LaserBase MF6530
LaserBase MF6540PL
LaserBase MF6550
LaserBase MF6560PL
LaserBase MF6580PL

MF6500-005
(F9-T01-M00-10015-01)

Preventing the outer paper delivery roller from coming off

P-1 Fixing assembly

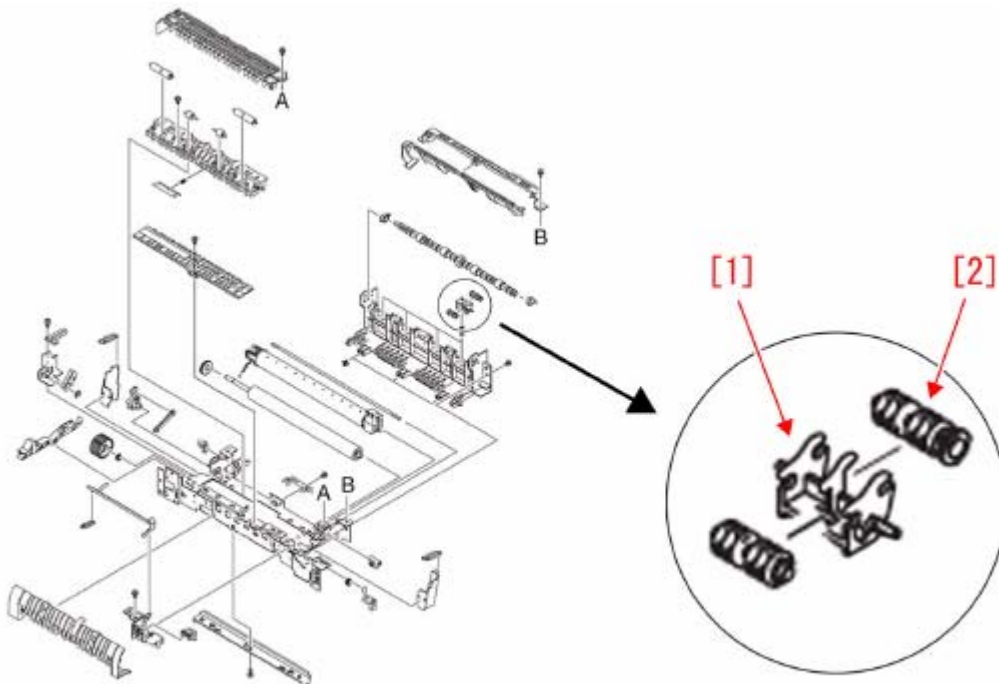
In order to make the outer paper delivery roller [2] of the fixing assembly less likely to come away from the roller holder [1], the shape of the roller holder is modified (P-2) so that the direction in which paper is sent after fixing will be opposite to the one in which the outer paper delivery roller comes away.

P-2 Roller holder
[3] Locations where the shape is modified

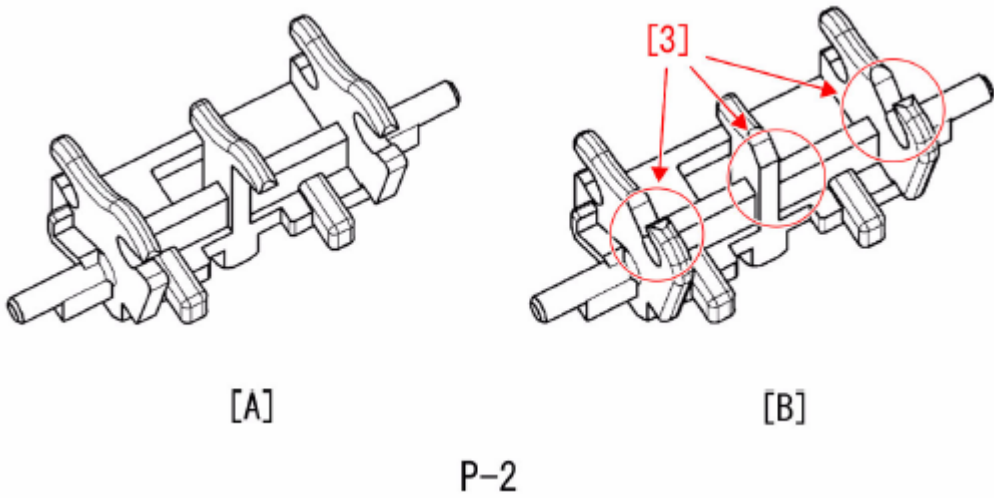
Points to note about service work:
Although the attachment/ detachment direction of the outer paper delivery roller varies depending on the type of the roller holder, the position where the roller is mounted is the same. Therefore, coexistence of the new and old roller holders will cause no functional problem.
